CONTRACT CHANGE ORDER NO. _____
SHEET ___ OF ___

MARK	DATE	DESCRIPTIONS	BY	CH'D	CCO#
2	04/08/11	SUSPENSION CABLE MISCELLANEOUS DETAILS	GB	MN	185
1	01/28/11	MISCELLANEOUS CABLE SYSTEM DETAILS	GB	MN	37S1

SAN FRANCISCO OAKLAND BAY BRIDGE
EAST SPAN SEISMIC SAFETY PROJECT
SELF-ANCHORED SUSPENSION BRIDGE
(SUPERSTRUCTURE & TOWER)
EAST CABLE ANCHORAGE "E" LINE LAYOUT NO. 2

EAST CABLE ANCHORAGE DETAILS

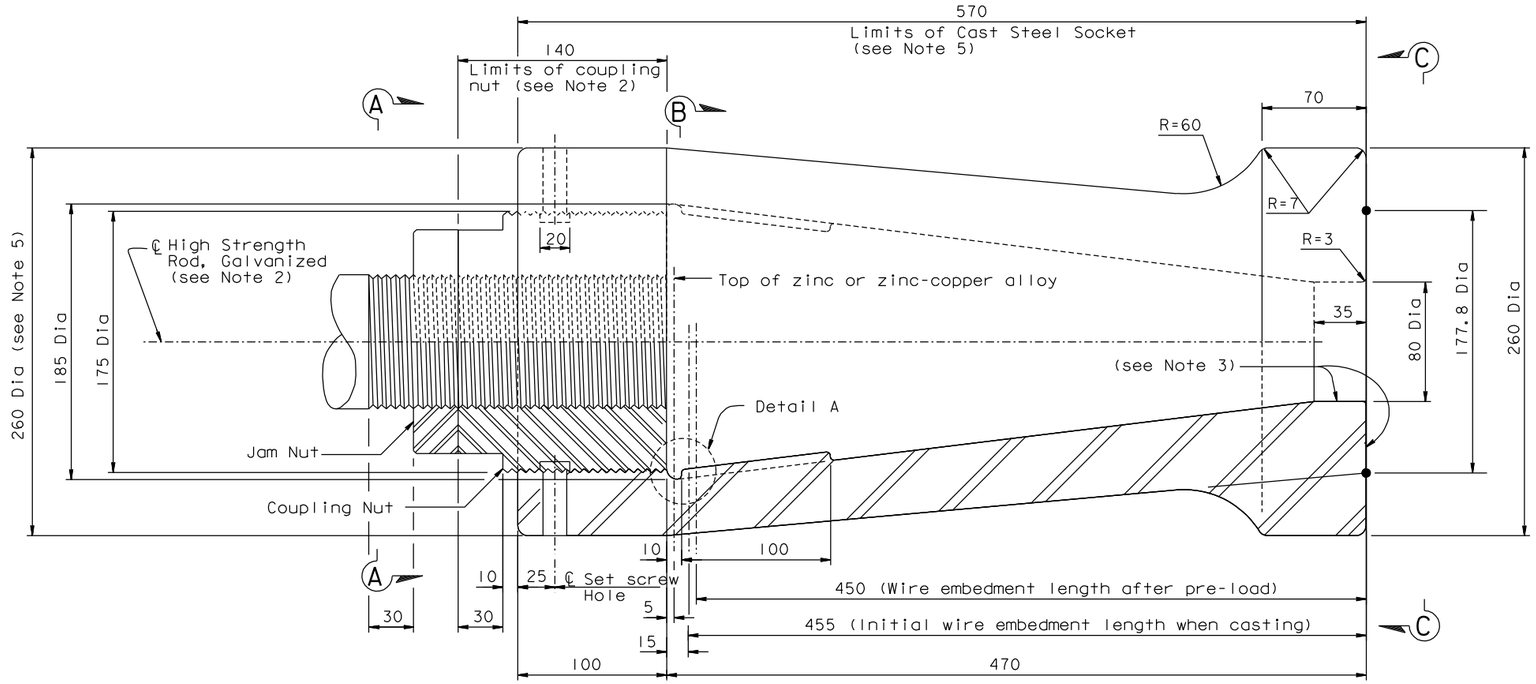
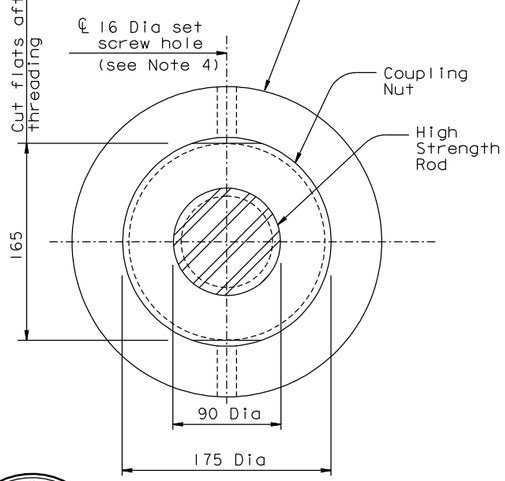
1. Coupling nut and socket shall conform to ASTM A194 GR 7, with 4 threads per inch.
2. For main cable strand anchor rod and cable strand socket materials, see "General Notes" sheets.
3. Surface shall be finished to ANSI 500.
4. Provide 16 Dia stainless set screws in threaded hole.
5. All socket dimensions are for information only. The Contractor shall develop socket details consistent with his means and methods and the east cable anchorage geometry, and shall submit them to the Engineer for review and approval. The socket dimensions shall be such that adequate prestressing and erection clearance is provided.
6. Material for bearing blocks shall be ASTM A668 Grade F, or ASTM A148 Grade 550-345.

SUSPENSION CABLE MISCELLANEOUS DETAILS NO.1

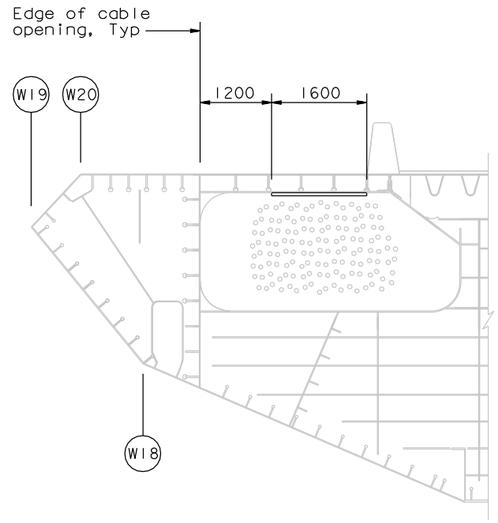
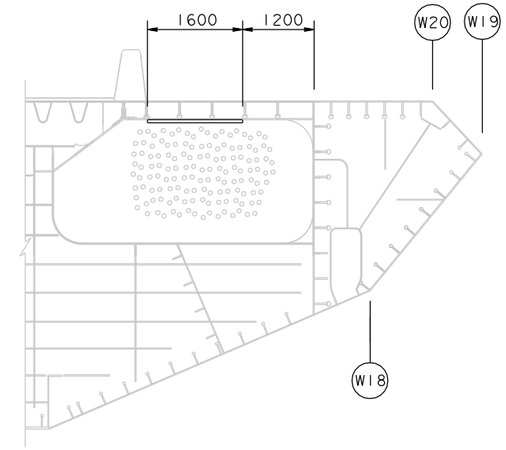
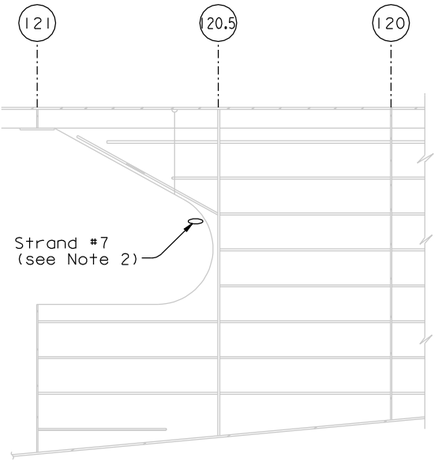
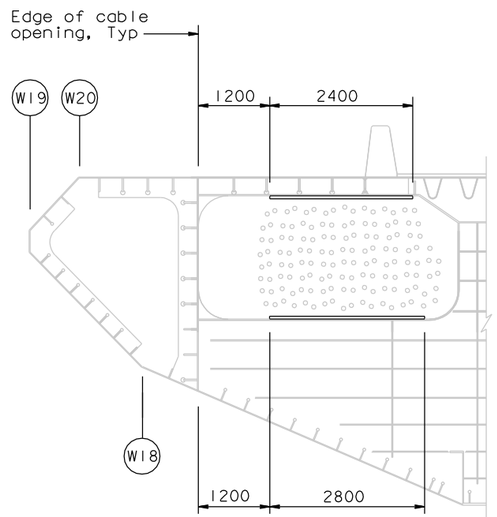
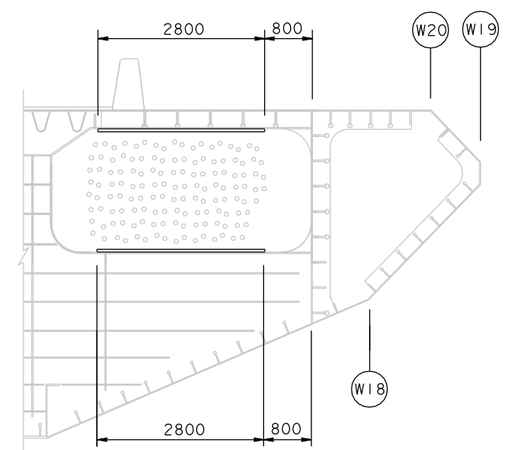
1. For details of neoprene pad at cable opening flanges, see "Suspension Cable Miscellaneous Details No.6" sheet.
2. Strand #7 shall be wrapped in the vicinity of the K plate per the "PWS Strand Sheathing" detail on "Suspension Cable Miscellaneous Details No.4" sheet.

SUSPENSION CABLE MISCELLANEOUS DETAILS NO.2

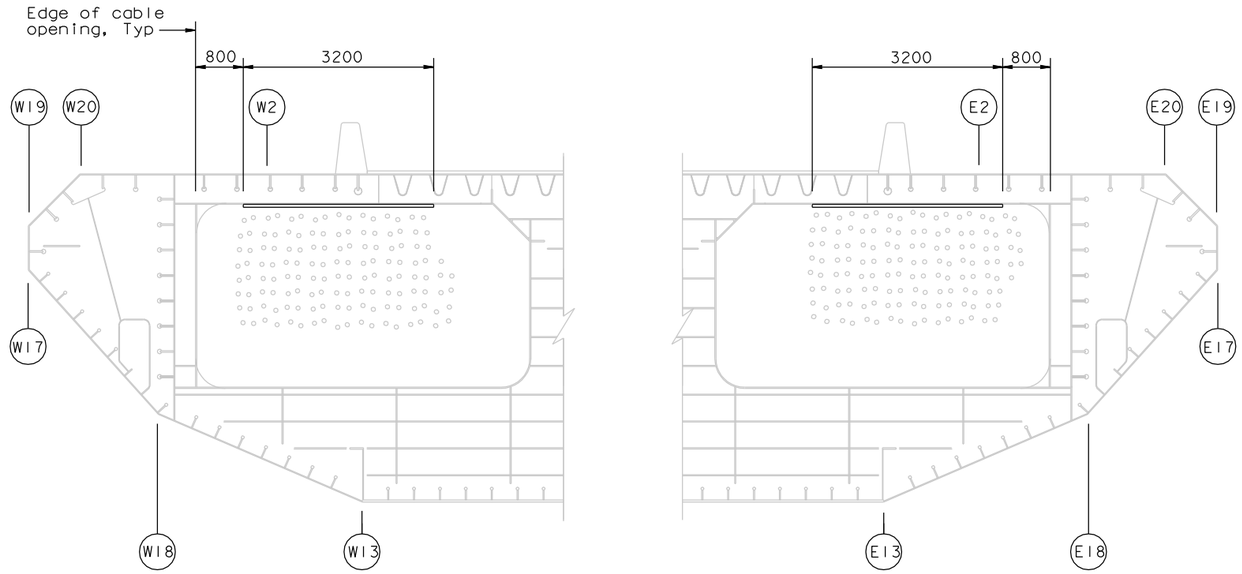
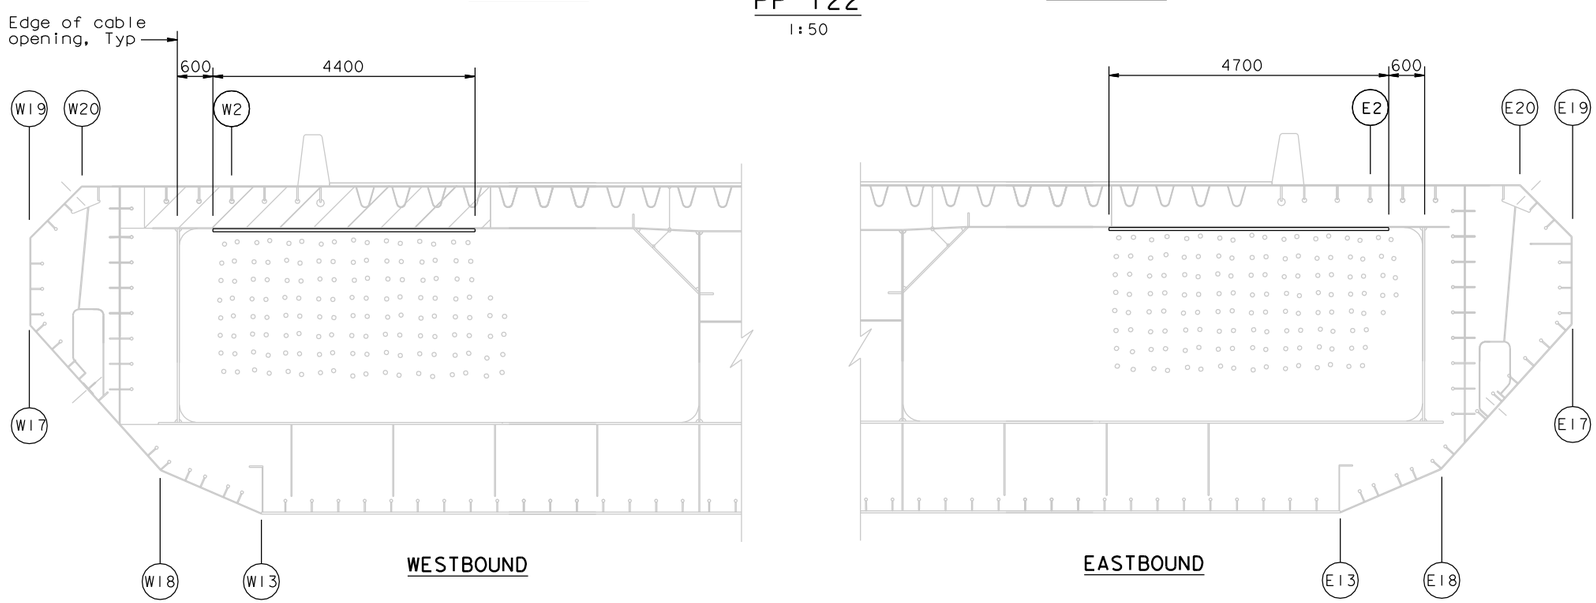
1. For details of neoprene pad at cable opening flanges, see "Suspension Cable Miscellaneous Details No.6" sheet.
2. Protection for PWS strands is not required at PP 122.5 (EB & WB).

PP 123.5
1:50

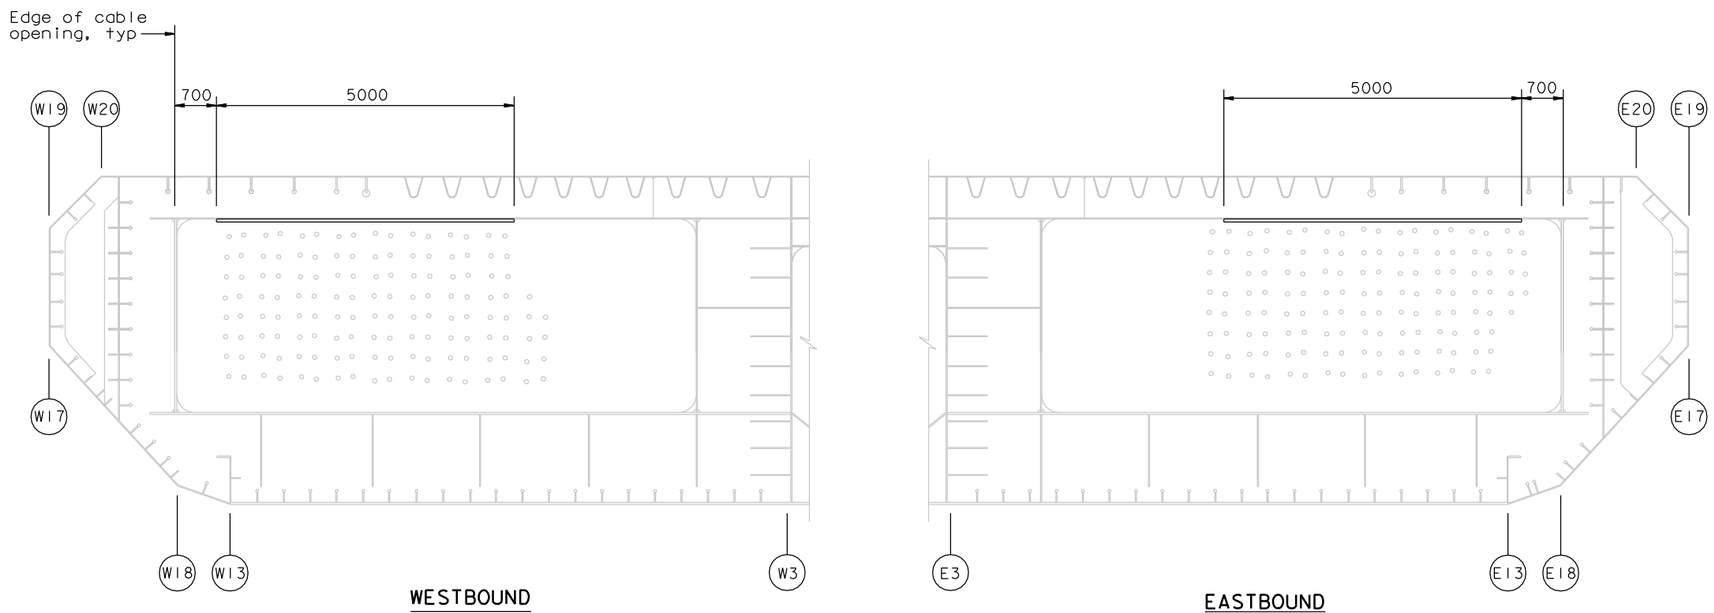
1. For details of neoprene pad at cable opening flanges, see "Suspension Cable Miscellaneous Details No.6" sheet.
2. Protection for PWS strands is not required at PPs 124 & 124.5 (EB & WB).

PWS STRAND SHEATHING
1:5

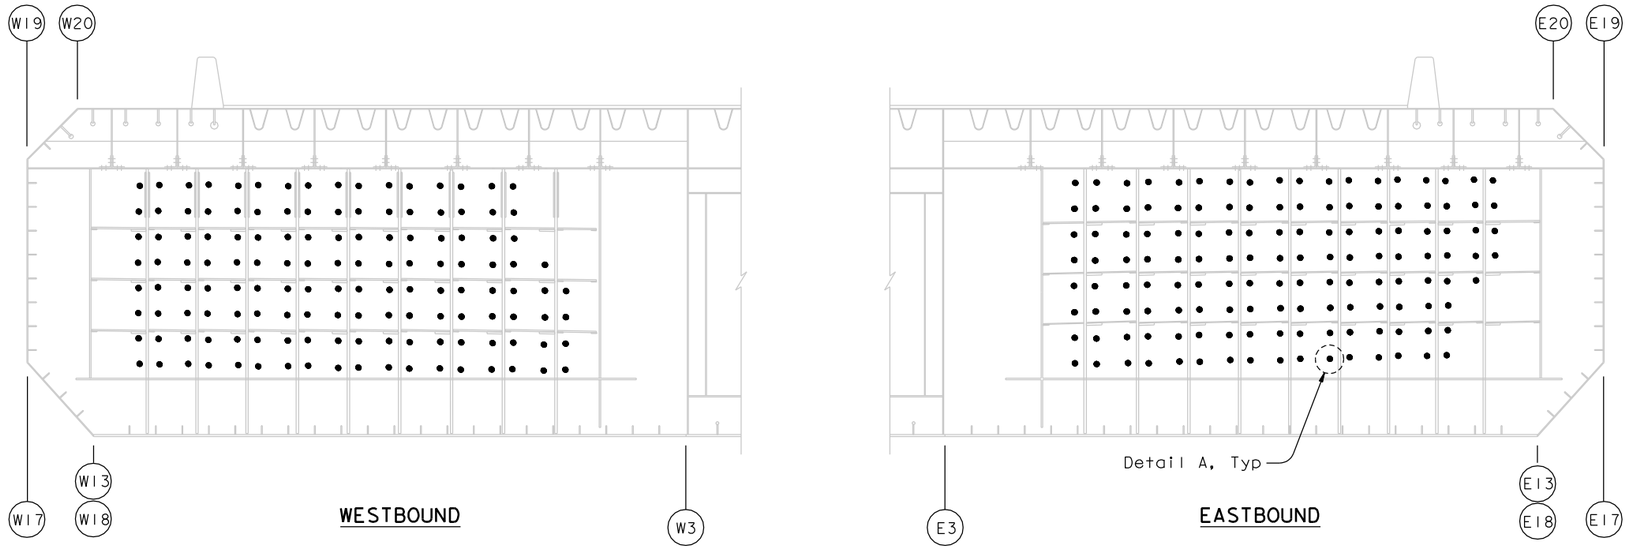
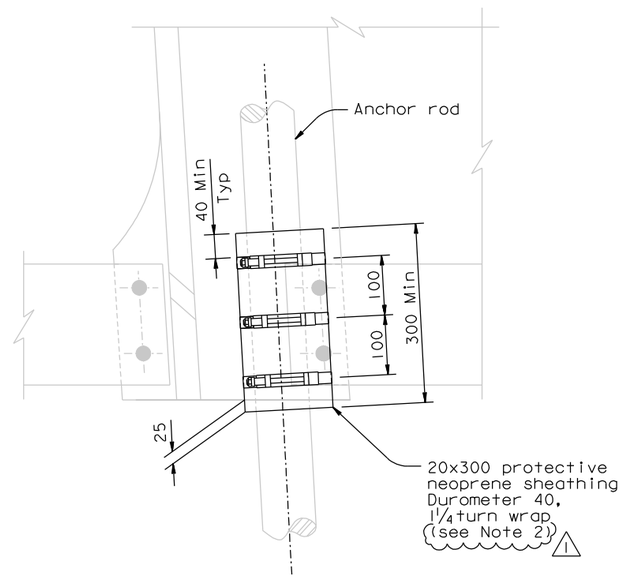
1. The Contractor shall provide twenty spare protective neoprene sheathing wraps.
2. At the Contractor's option, the neoprene sheathing can be wrapped (1) turn, subject to review and approval of the Engineer.

SOCKET WITH NEOPRENE WRAP
1:5

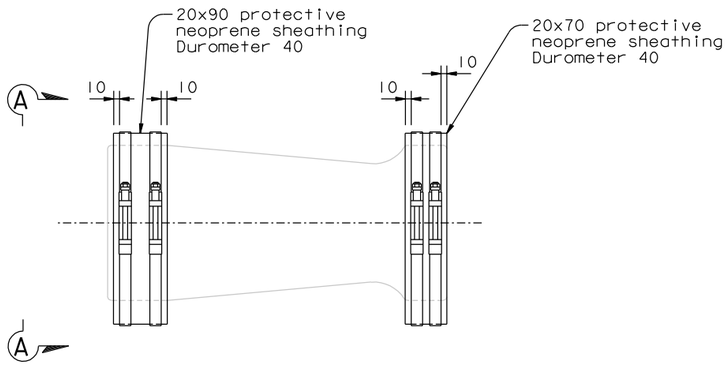
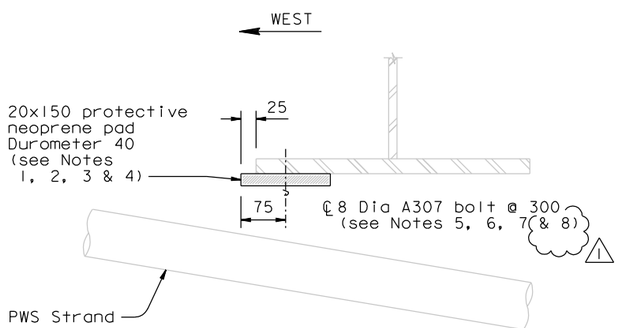
1. Neoprene pad shall be installed prior to free hanging cable installation.
2. At the Contractor's option, the neoprene pad may be installed in segments. A maximum gap of 5 mm is allowable between segments.
3. The Contractor shall provide bonding material and installation procedure for review and approval of the Engineer.
4. The Contractor shall use Chemco Systems CCS grout, Dowel/ Rebar/ Bolt/ LWL, or equivalent, to bond the neoprene pad to the flange.
5. Bolts shall be installed with head on the strand side of the flange, with a 20 Dia washer under the bolt head.
6. Bolts shall be installed snug tight + ½ turn.
7. Nuts shall be installed with thread locking compound.
8. At the Contractor's option, imperial fasteners may be provided, subject to review and approval of the Engineer. (1)

TYPICAL CABLE BAND DETAIL
1:5

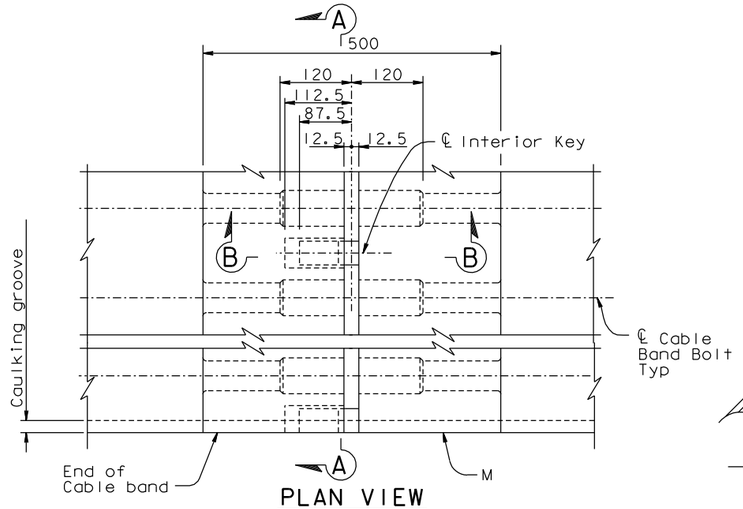
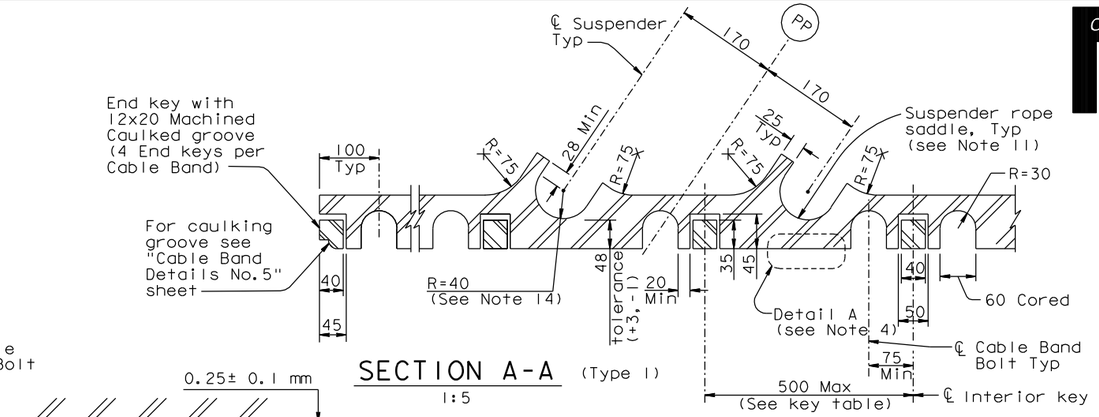
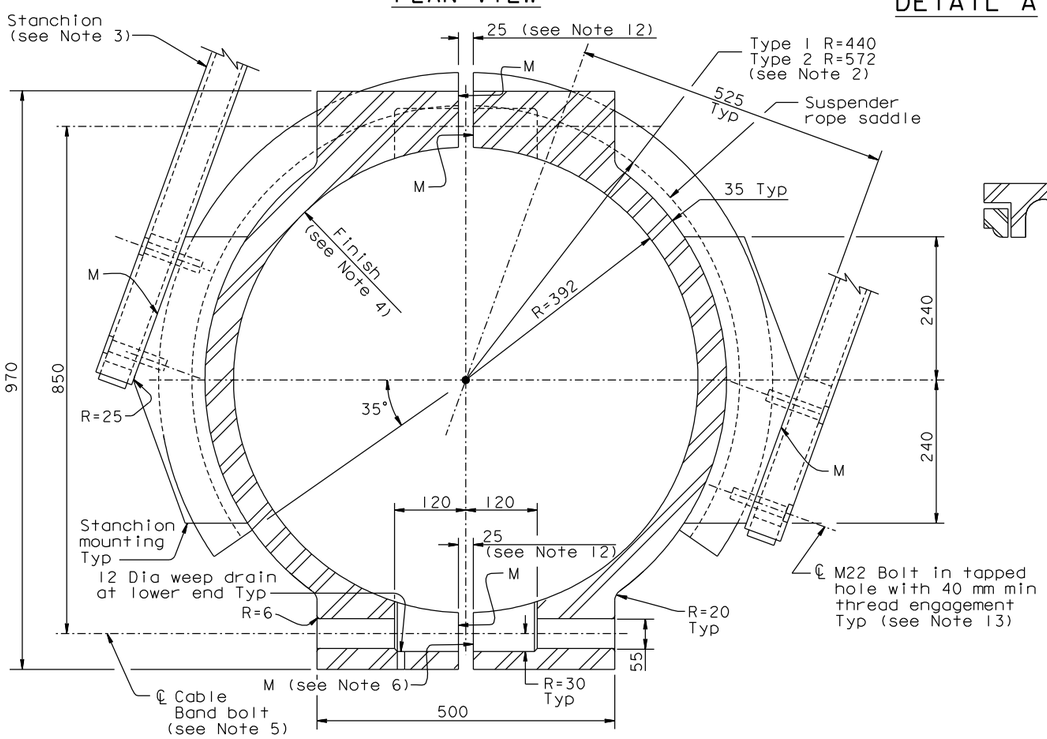
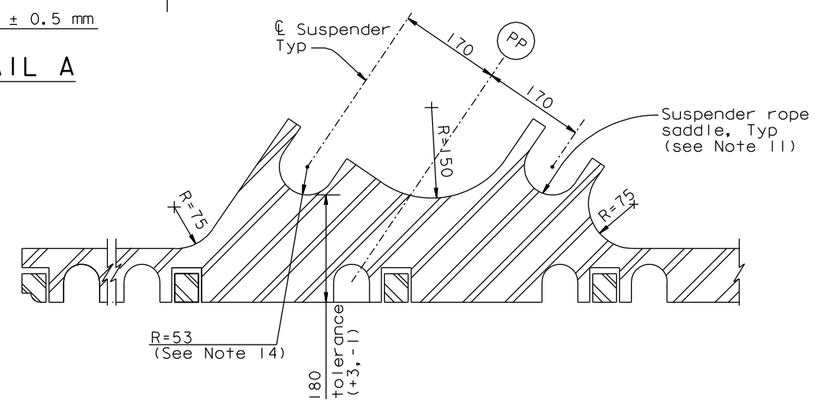
4. Cable band bore shall be finished with 650 cuts per meter with depth of 0.25 mm at right angles to the cable axis, as shown in Detail A.
5. For cable band bolts, see "Cable Band Details No.5" sheet. For materials of cable and bolts, see the "General Notes" sheets.

6. All surfaces identified with the letter "M" shall be spacially placed in the plane identified, within 2 mm. These surfaces shall not deviate in flatness from the specified plane more than ±0.0015 times the length over which the flatness is measured. Surface roughness of exterior surfaces with no machining shall be finished to ANSI 1000.

12. The full depth of the opening between the cable band halves shall be sealed. For sealing details, see "Cable Band Details No.3A" sheet. The top opening shall be fully sealed. The bottom opening shall be fully sealed, except as shown in the Lower End Caulking Detail, see "Cable Band Details No.5" sheet.
